# MISO Regional Transmission Overlay Study Breakout Session – South Region Preliminary Overlay Results

**Economic Planning Users Group (EPUG)**

May 25, 2017

# May 25<sup>th</sup> EF Overlay Updates South Region (2/3)

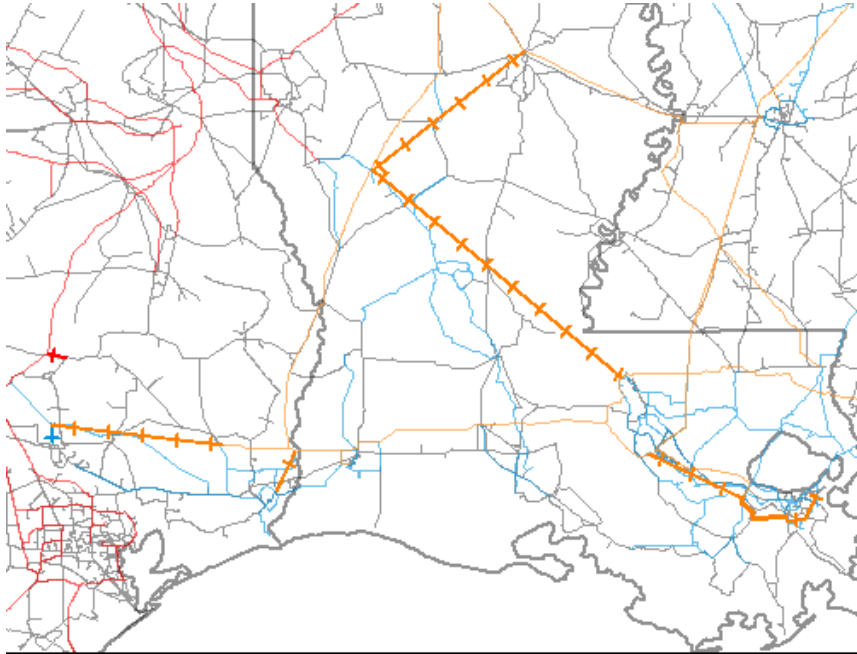
- Add Hartburg – Sabine 500 kV (S37)
- Remove 230 kV Rivtrin – Hartburg/Layfield 500 kV tap (S34)
- Remove Layfield – Longwood/Sarepta 345 kV tap (S13)
